**ASI-18**

Date: October 4, 2022

Project: DelDOT Georgetown Administration Building

Project No: T202180102

1
**ENCLOSURE AT COLUMN F-19**  
 ASK-11 SCALE: 1 1/2" = 1'-0"

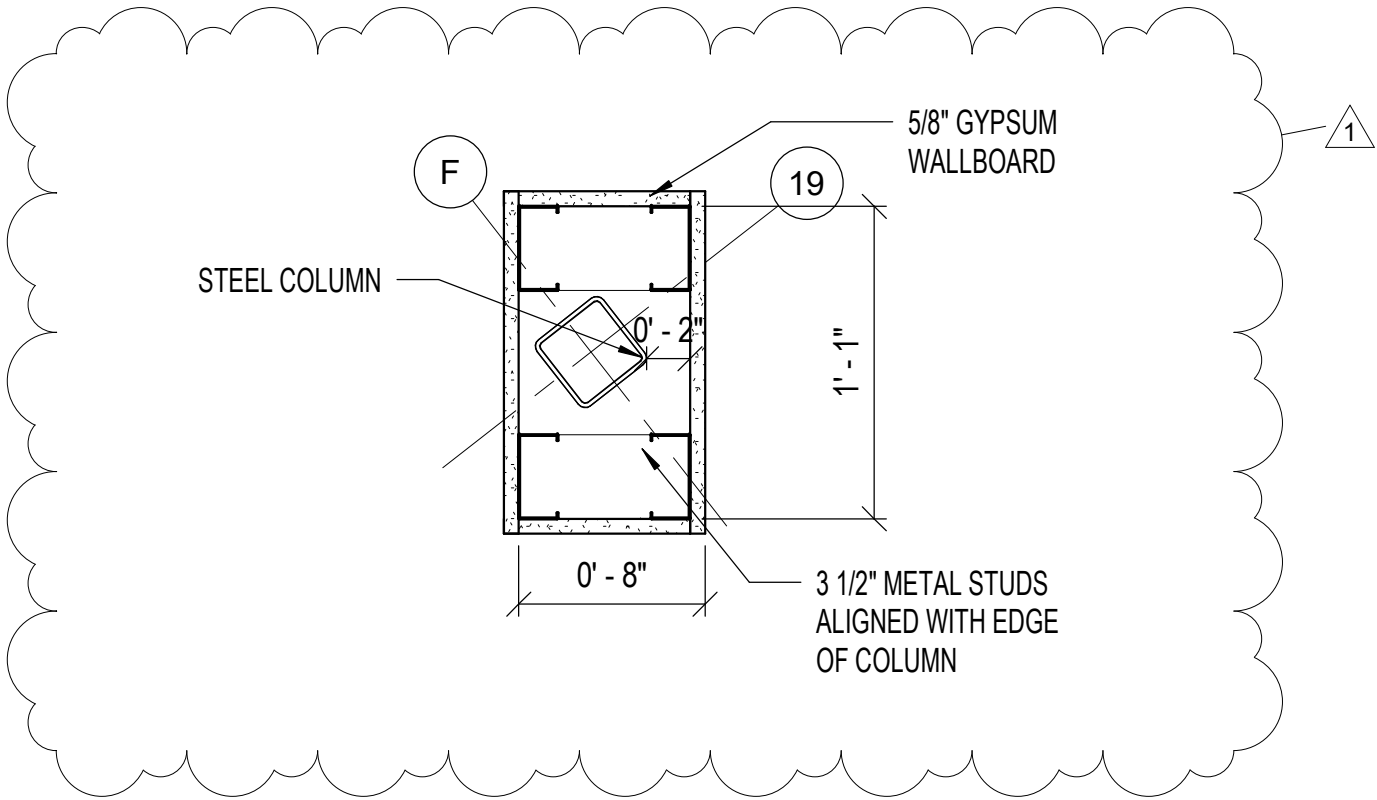
1. Change column enclosure at column F-19 for new furniture layout and additional wiring/data junction boxes.
2. At Conference Room B101, remove existing exterior ADA door opener post with push plate actuator. Remove and store push button and any hard wired connections or wireless transmitters. Repair existing concrete sidewalk. Furnish and install new steel pedestal matching new front door ADA door opener post. Reinstall door operator and wiring/transmitters.

1. See sketch ASK-11.
